Access Compliance Report

Public Rights-of-Way (Curb Ramps)

Intersection ID: 26060	Main Street: FLOWERING_DOGWOOD_LN	Cross Street: PROVIDENCE_GLEN_RD	Location: E
ADA ID: 5665C14585AE	Ramp Type: Perp	Initial Pass/Fail: Fail	Overall Compliance: No
Codes/Mitigation Info/Possible Solution		Field Measurements/Component Compliance	
Severity Score: 46.25

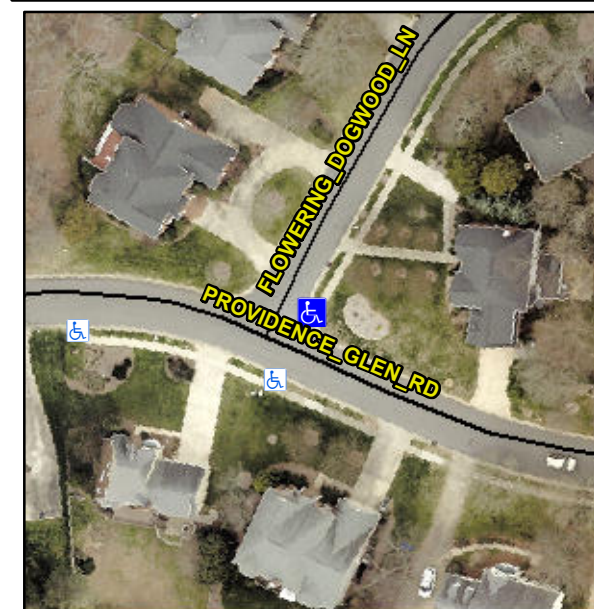
Not Found, R304.5.1, R304.2.2, R304.5.3

Compliance	Description	Data	Compliance	Description	Data
N/A	Ramp Length (in)	59.0	No	Ramp Slope (%)	12.6
No	Ramp Width (in)	47.0	No	Ramp XSlope (%)	6.0
N/A	Flare Type LT	N/A	N/A	Flare Type RT	N/A
N/A	Flare Slope LT (%)	N/A	N/A	Flare Slope RT (%)	N/A
N/A	Flare Traversable LT?	N/A	N/A	Flare Traversable RT?	N/A
N/A	Landing Length (in)	N/A	N/A	DWS Provided?	N/A
N/A	Landing Width (in)	N/A	N/A	DWS Contrast?	N/A
N/A	Landing Slope (%)	N/A	N/A	DWS Length (in)	N/A
N/A	Landing X Slope (%)	N/A	N/A	DWS Full Width?	N/A
N/A	Landing Curb? (Y/N)	N/A	N/A	DWS Offset (in)	N/A
N/A	Shared Landing?	N/A			
N/A	Gutter Ponding?	N/A	N/A	Gutter Slope (%)	N/A
N/A	Gutter Lip Ht (in)	N/A	N/A	Gutter X Slope (%)	N/A
N/A	Painted X Walk1?	No	N/A	Painted X Walk2?	N/A
	X Walk 1 Direction	To S		X Walk 2 Direction	N/A
N/A	X Walk 1 Width (in)	N/A	N/A	X Walk 2 Width (in)	N/A
	X Walk 1 Slope (%)	1.5		X Walk 2 Slope (%)	N/A
	X Walk 1 X Slope (%)	0.1		X Walk 2 X Slope (%)	N/A

Remove & Replace Entire Ramp.
